Local Planning Panel

Address: 806-812A George Street, Haymarket

D/2025/33

Proposal

Flooding

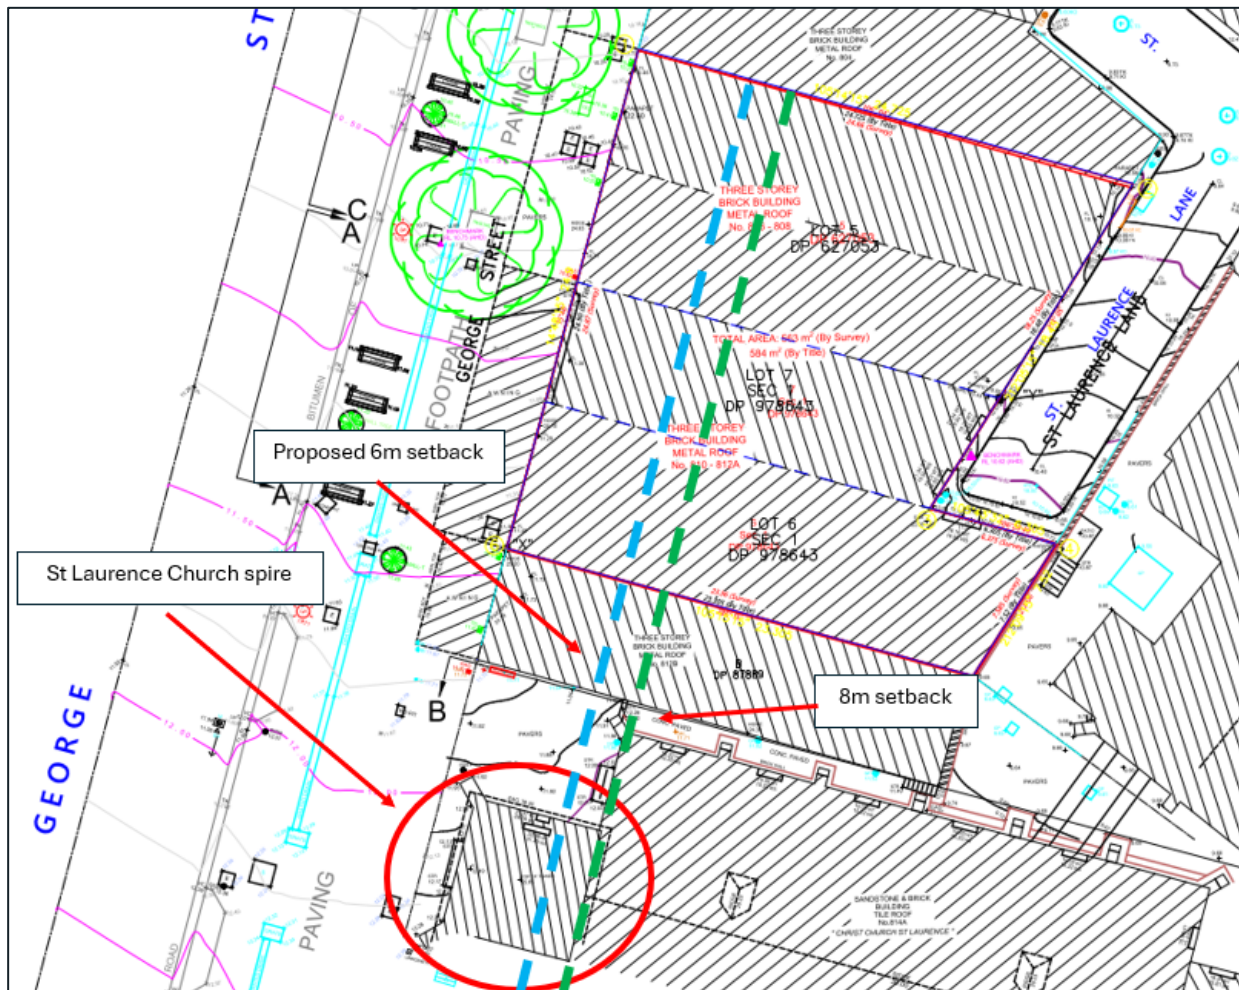
- The site is identified as being subject to flooding
- Proposal does not comply with a flood planning level of 1% AEP + 500mm or PMF, whichever is the higher.
- Consent cannot therefore be granted pursuant to Clause 5.21 of the SLEP 2012

View analysis depicting a compliant building envelope, looking south along George St from the intersection with Ultimo Rd

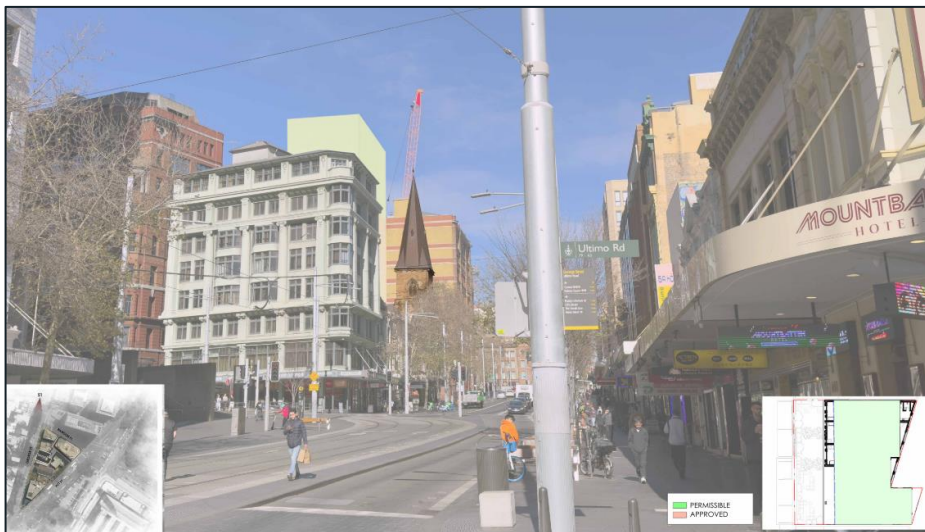
- The site is located within the Haymarket/ Chinatown Special Character Area
- DCP requires a minimum setback of 8m above the street frontage height to George St
- The proposal provides a 6m setback from Levels 4 and above, with the southern portion of the building providing 10m setback on Levels 7-14
- The 6m setback would likely impact on the visual significance and setting of the neighbouring Christ Church St Laurence

Level 12 plan highlighting the area of void and risers

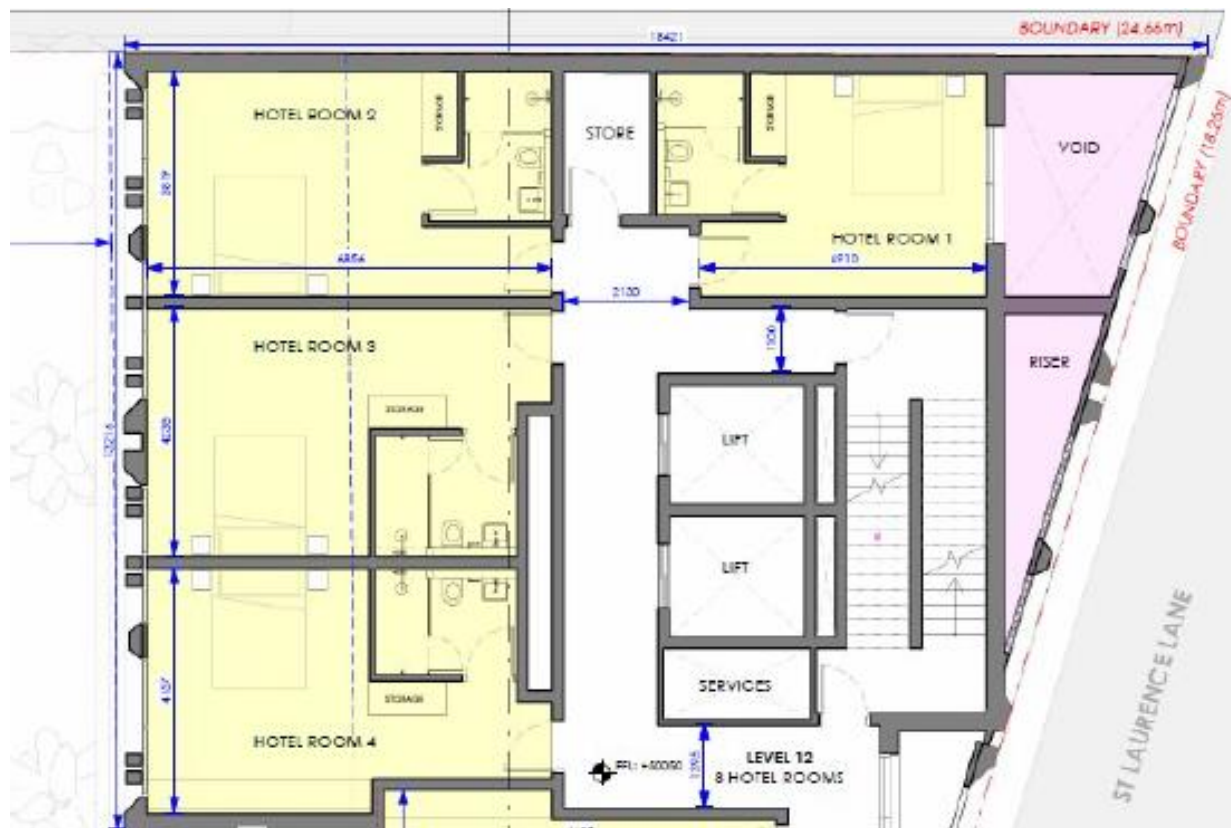
- Substantial non-compliances with DCP controls
- Significant shortfall in communal recreational areas (80 sqm)
- Poor amenity to internal corridors
- Solar heat gain and visual privacy concerns from large glazed panels
- Noise and light spill issues from common areas and services close to bedrooms
